TO: East Grand Rapids Planning Commission
FROM: Jay Gianotti, Zoning Administrator
DATE: January 7, 2026

RE: **Site Plan Approval for a Parking Garage Expansion at 1840 Wealthy St. SE**
(PPN: 41-14-33-127-014)
Zoned: R-1 Single Family Residential

Corewell Blodgett Ramp 2 Vertical Expansion Site Plan Review Project Update

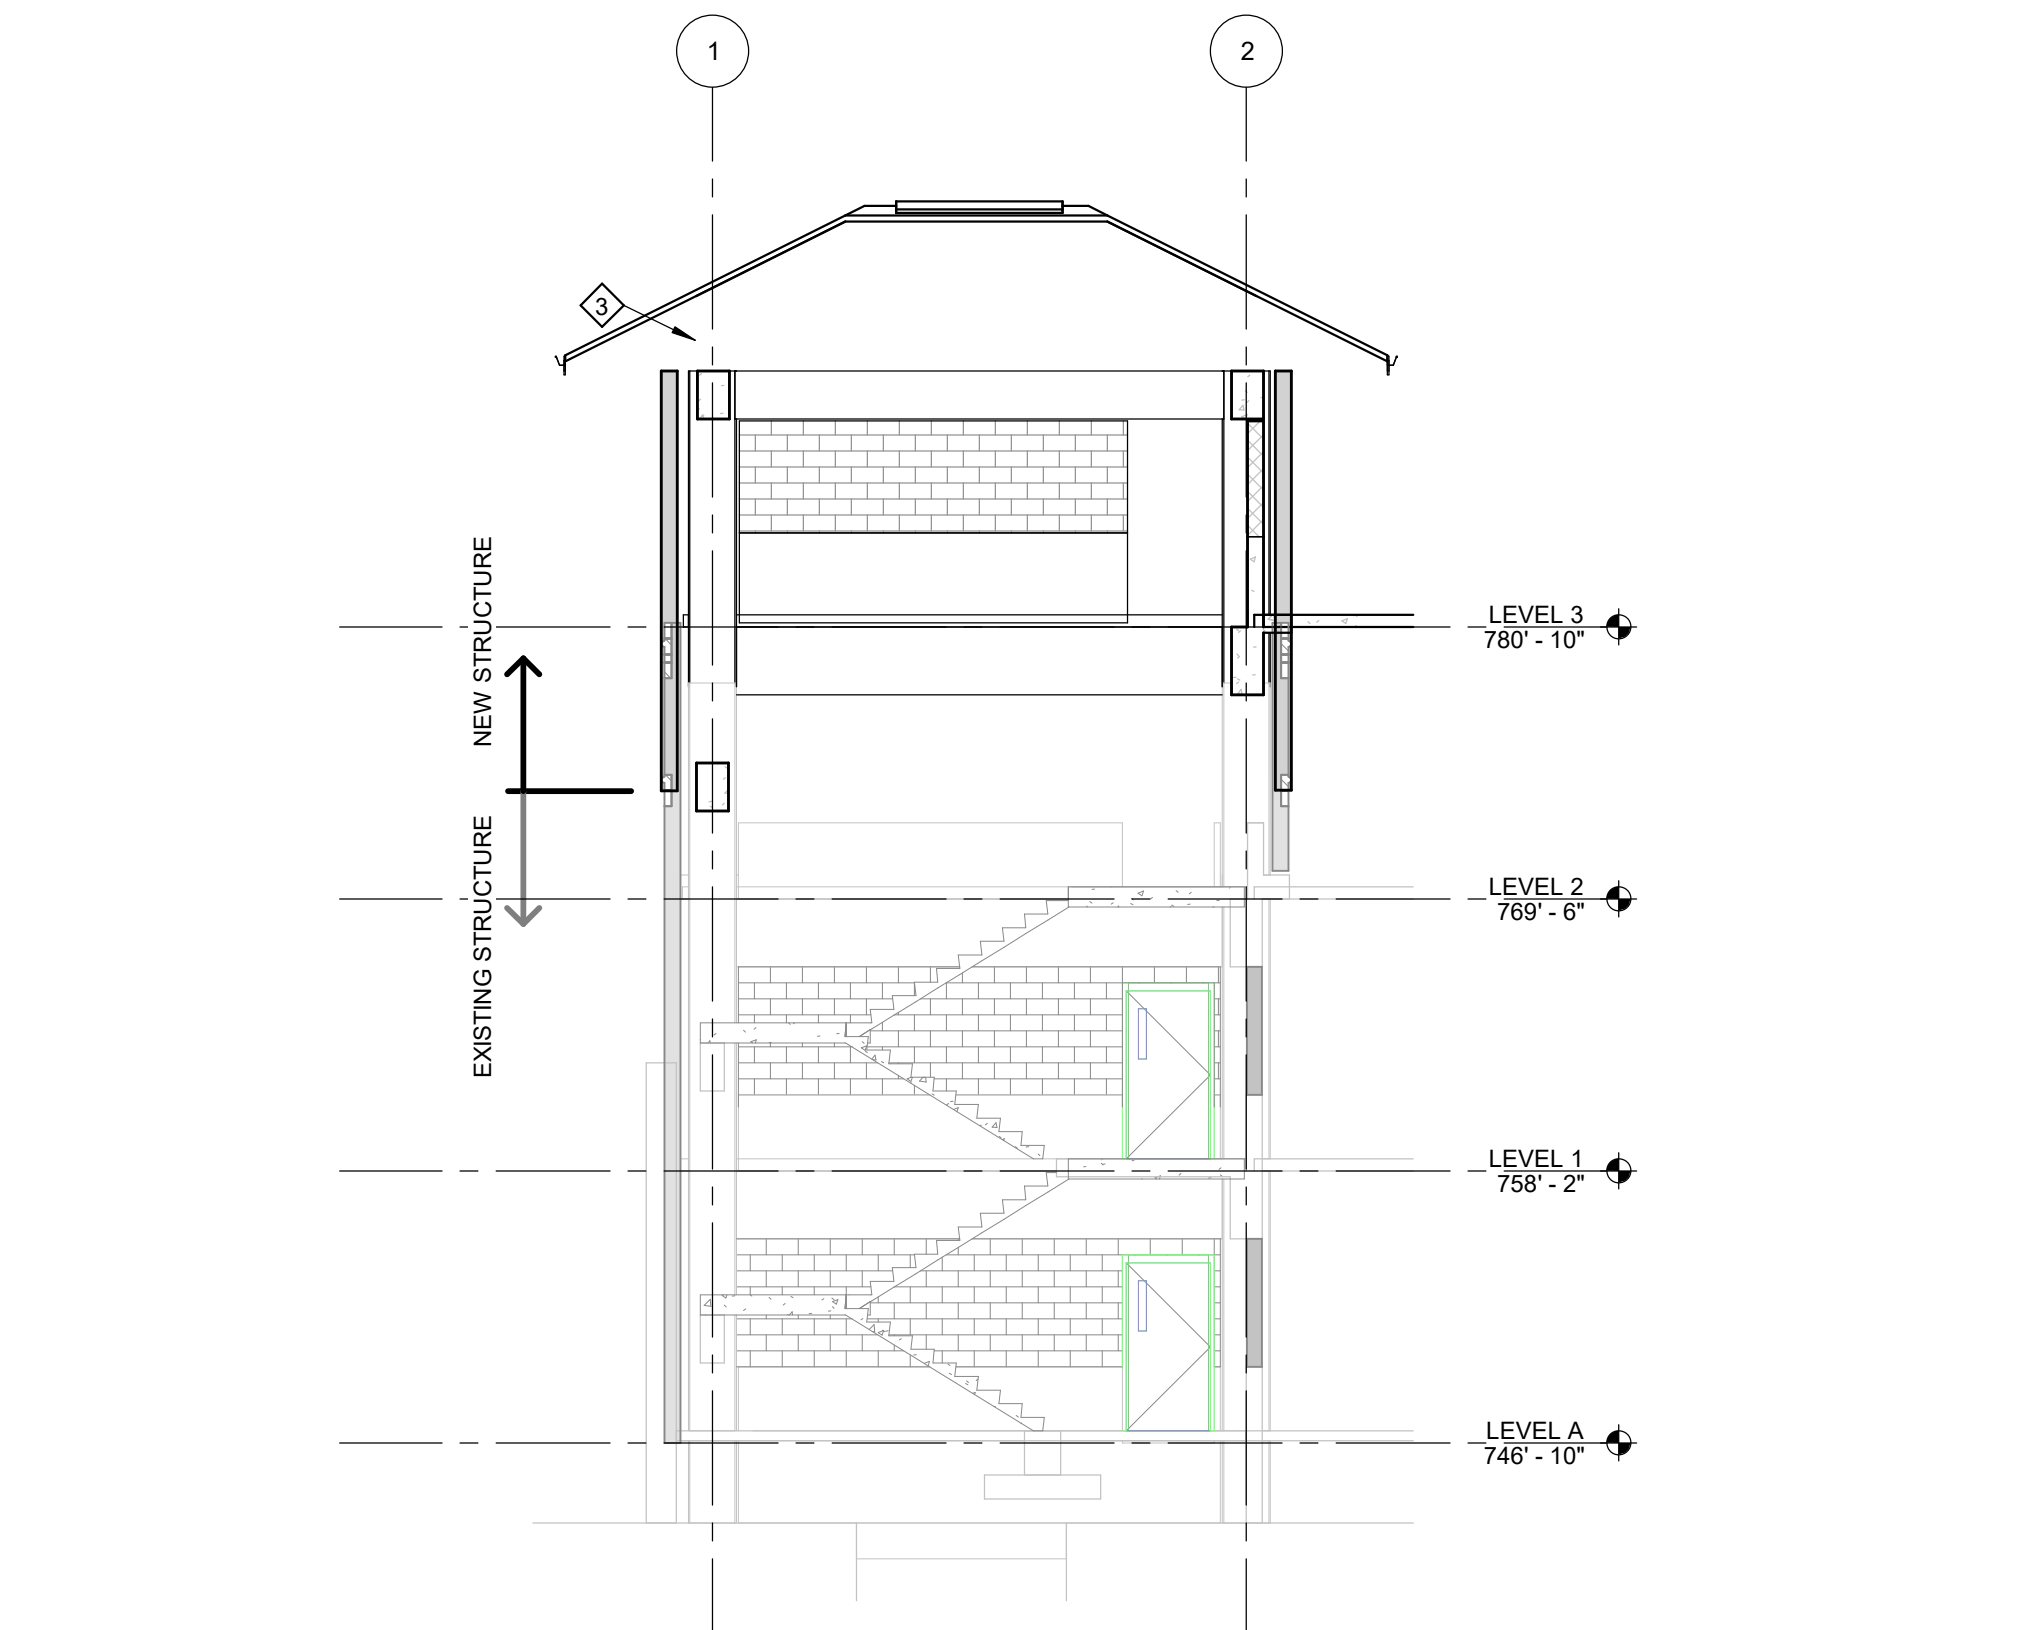
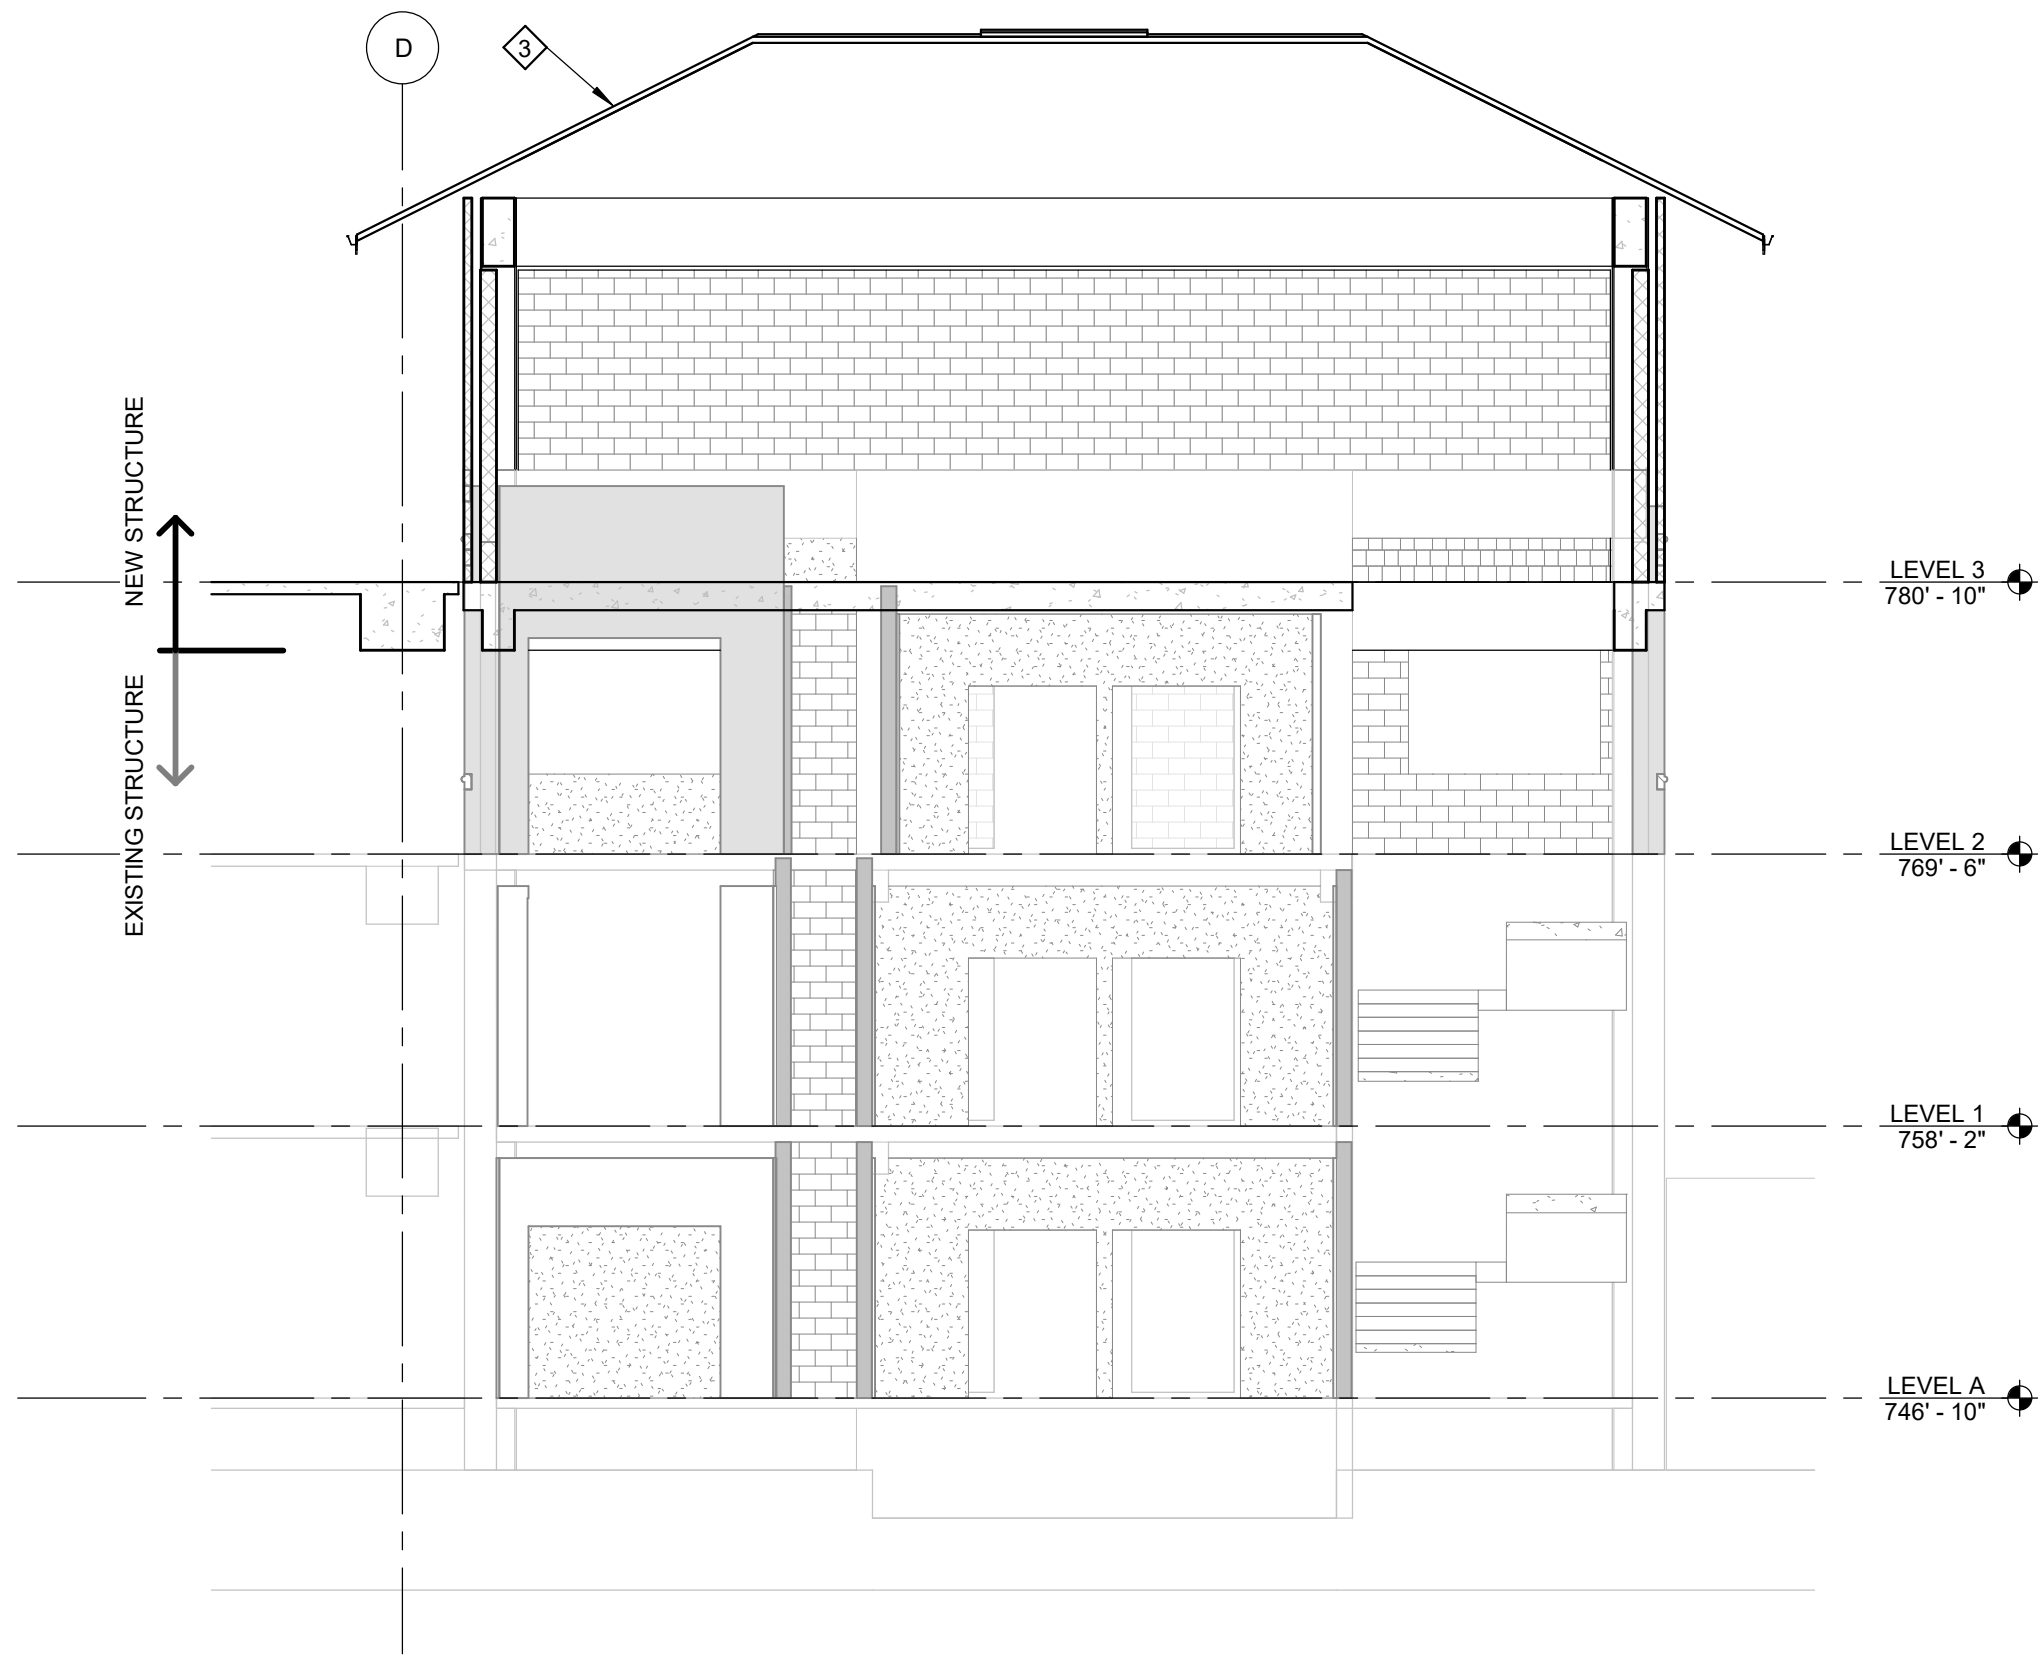
- Number of stories: In the R-1 District, buildings may not exceed 2.5 stories. While the submitted drawings list four levels of parking, this does not necessarily translate to a four-story building. Level A would be more than 50% underground or below grade, so it would not count as a story. Similarly, Level 3 is entirely open to the air. This would then function as the roof of the building, not a story itself. Thus, for zoning purposes, the City would consider the proposed garage modification to constitute a two-story building.
- Building Height: In the R-1 District, buildings may not exceed 35' in height. Because this is essentially a flat roof building, the height would be measured to the top of the roof. The City calculates the height of the proposed building as appx. 25'-10".² Exhibit 2 shows this calculation graphically. In summary:

² The renderings provided by the applicant ("west elevation" on the "Exhibit B: Renderings – Elevations" shows a measured height of 35' from the average grade to the midpoint of the stair tower. However, that rendering shows a level grade for much of the west elevation, whereas the elevation drawing on Sheet S301 shows more of a grade change along this face. As this appears to show more overall exposed building area, the City has taken its measurements from this latter drawing.
